Office Action Summary	Application No.	Applicant(s)
	10/695,867	YAMAWAKI, SHIGEMICHI <i>CH</i>
	Examiner Ninh H. Nguyen	Art Unit 3745

DETAILED ACTION

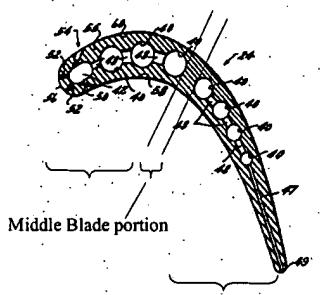
2. Claim 1 is rejected under 35 U.S.C. 102(e) as being anticipated by Kercher (3,542,486).

Kercher discloses a thin-walled lightweight cooled turbine blade (Fig. 3) constituting a front comprising front blade portion of the blade (see a reproduction of Fig. 3 below), a rear blade portion constituting a rear portion of the blade, and a middle blade portion located between the front blade portion and the rear blade portion and constituting an intermediate portion of the blade, the front blade portion comprised of front cooling air passages 40 that introduced cooling air into the interior thereof and front film cooling holes 52 for blowing out the cooling air from the front cooling air passages 40 to back and belly sides of the blade, the middle blade portion being solid structure, the belly side of the middle blade portion forms a recess portion towards the back side thereof, and high-temperature gas inherently flowing on the belly side of the blade branches once into two flows to the rear edge portion and along the belly side, and these branched high- temperature gas flows are merged again at the rear edge portion, thereby forming a separation region.
